14201 Southington Road

For a variance in order to enlarge the playground in the front yard.

STAFF REPORT

Shaker Heights Ludlow School – Pre K Renovation Variance Request

C-111

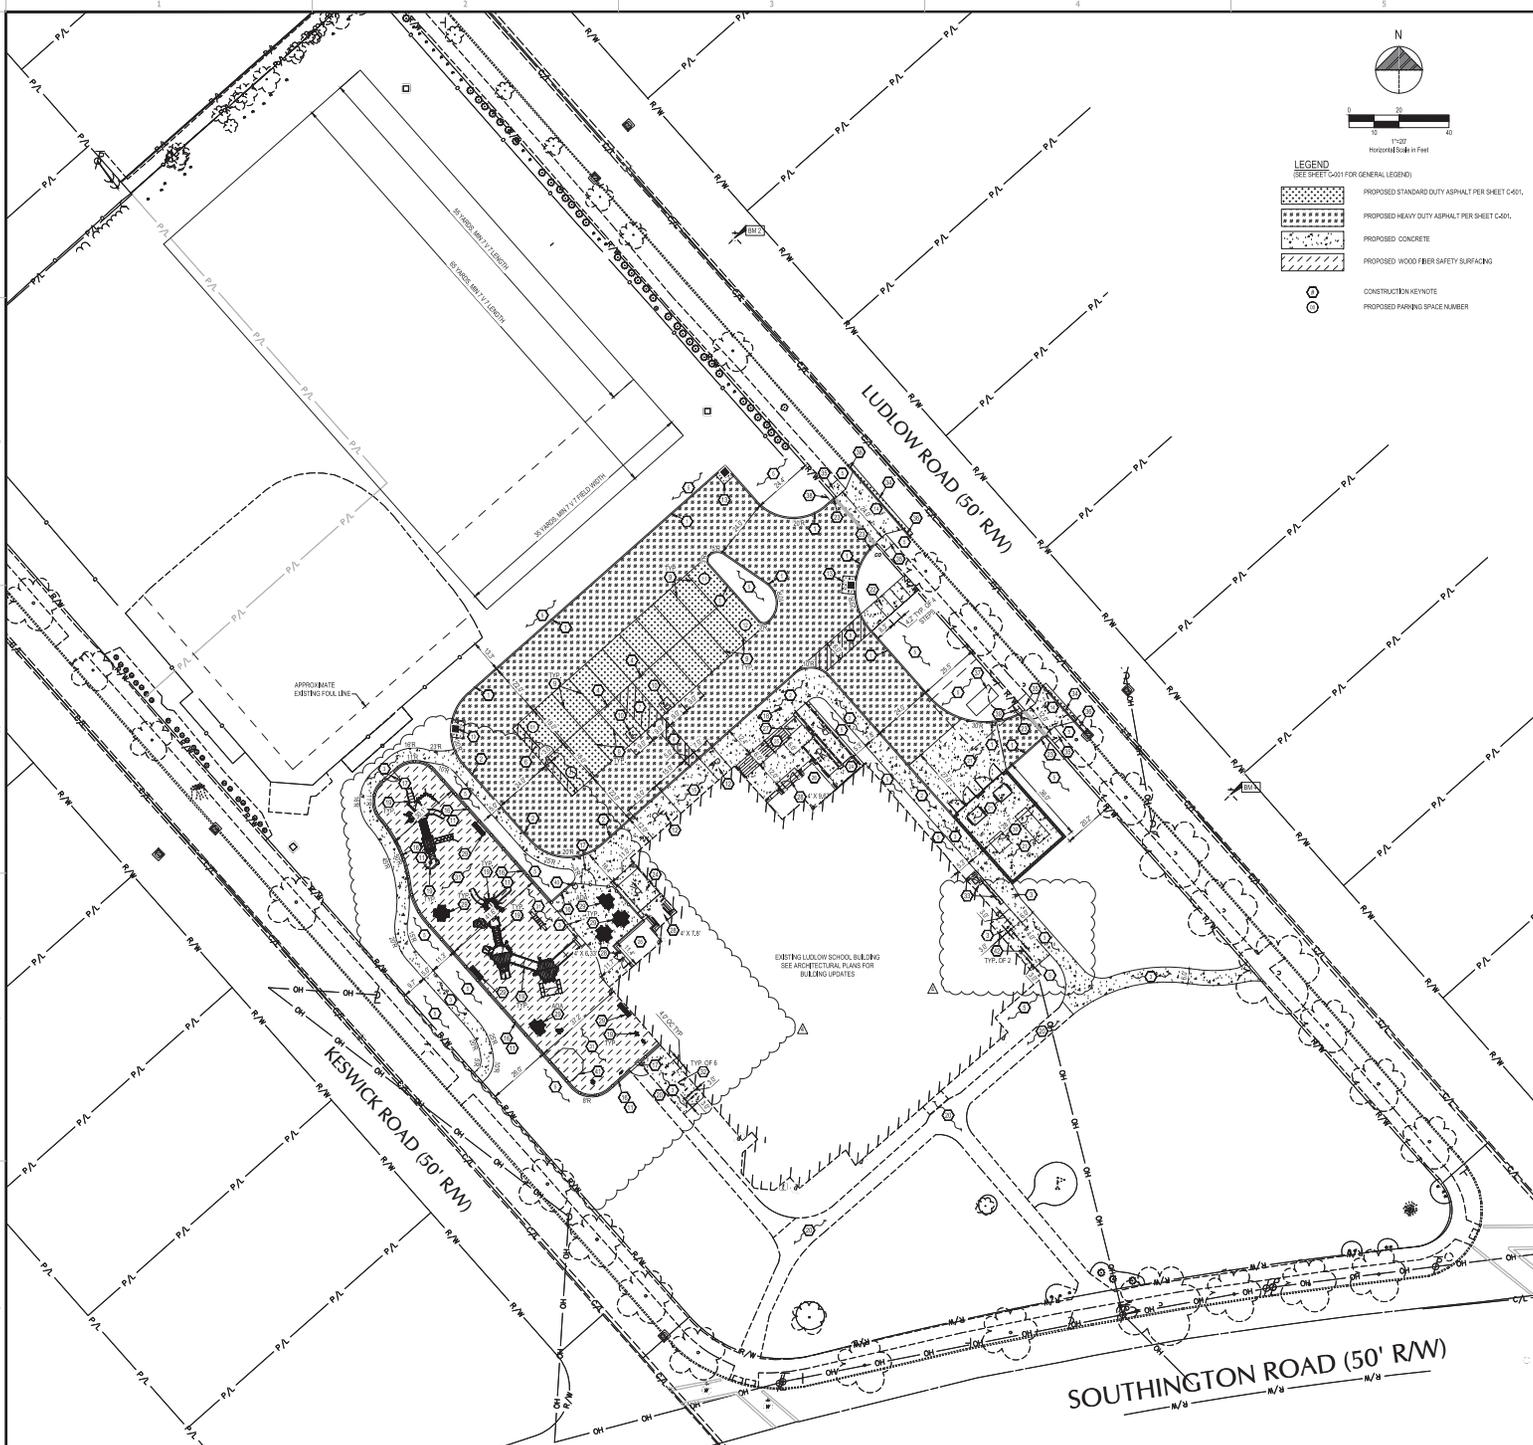
- Staff suggests approval with the following condition:
 - The addition of some trees to the playground area as approved by staff.
 - The bike racks on site should all match the “leaf” rack style specified near the playground.

- The addition of a straight path walkway to the Keswick Road sidewalk near the backstop.
- Based on:
 - Variances for the pre-school playground and fence were approved at the December 2024 meeting.

- The approved pre-school playground is proposed to be expanded to accommodate a community playground.
 - The extended playground is 1,600 square feet of additional playground space.

- The community playground has been designed in cooperation with the city and the neighborhood.
 - The City and School District are working together on the drainage issues that affect the Keswick Road sidewalk.

proposed tree additions . 4.30.2025

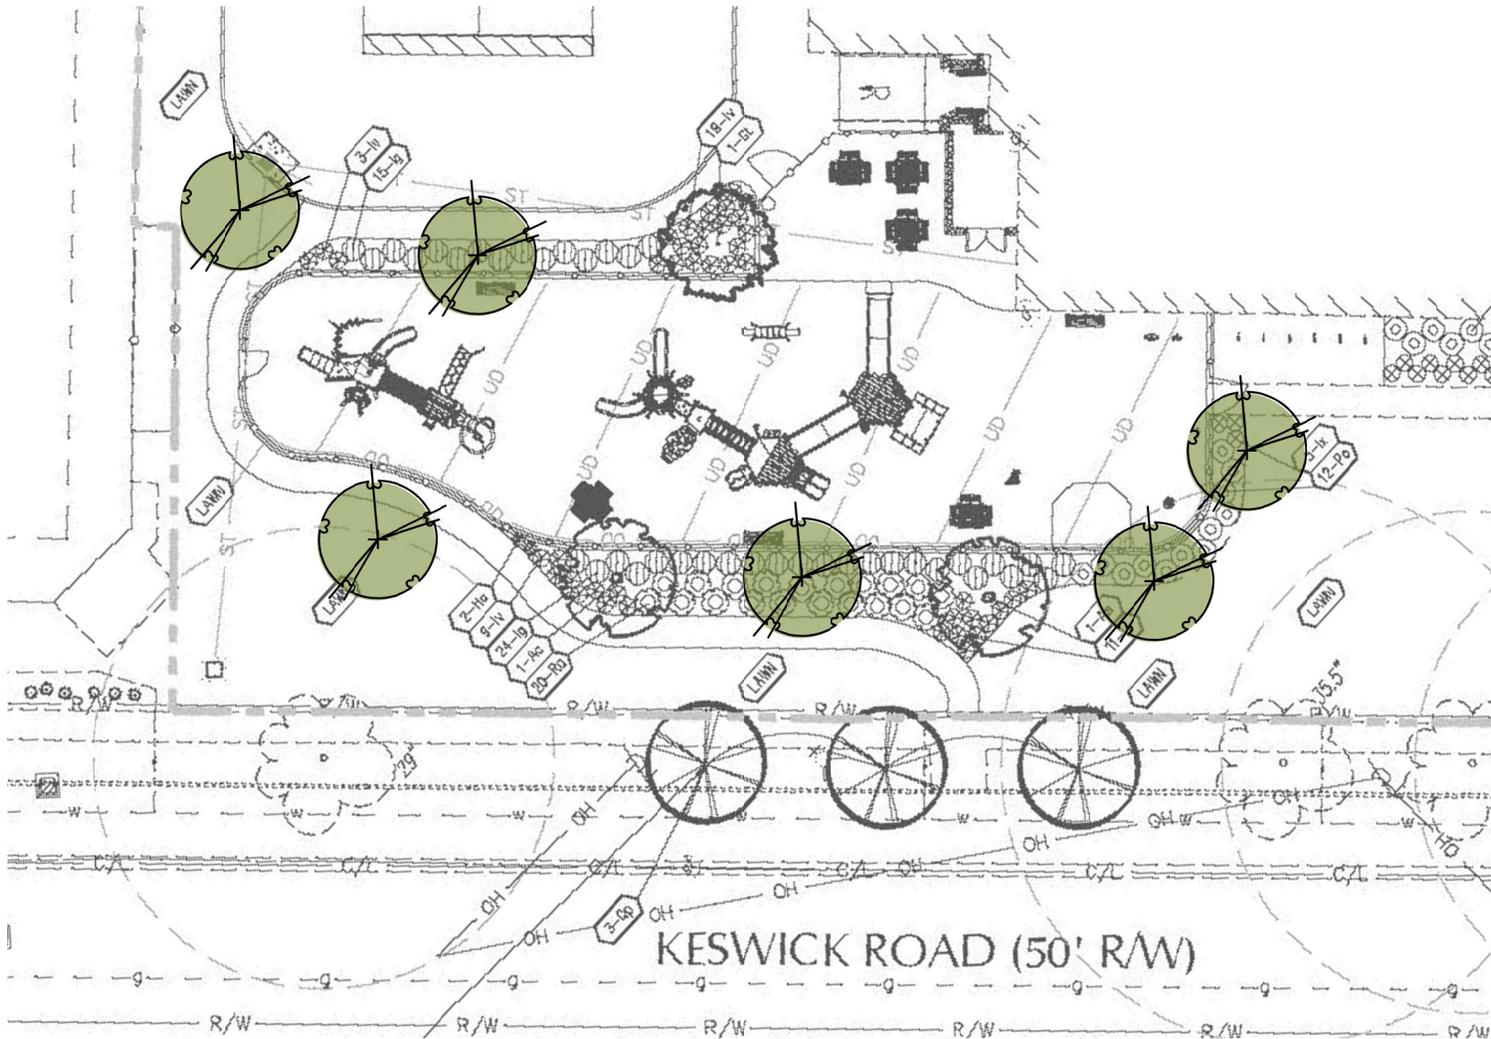
- **Additional trees:** The revised landscape design shows just three trees adjacent to the perimeter of the playground. As Shaker celebrates its 40th consecutive year receiving the Tree City USA designation, it is important to recognize how important generous tree plantings have been in creating the wonderful play spaces at all our other elementary schools.

Adding trees to the site plan will soften the edges of the playground, and reduce the impact of the encroachment into the front yard setback, the variance the applicant seeks. I have attached a sketch suggesting locations where six (6) trees could be added. I will also note that I have offered to the Shaker Schools Foundation to personally donate the full cost of these added trees. I ask that you incorporate their locations into your approval in the event that the Foundation chooses to accept our contribution.
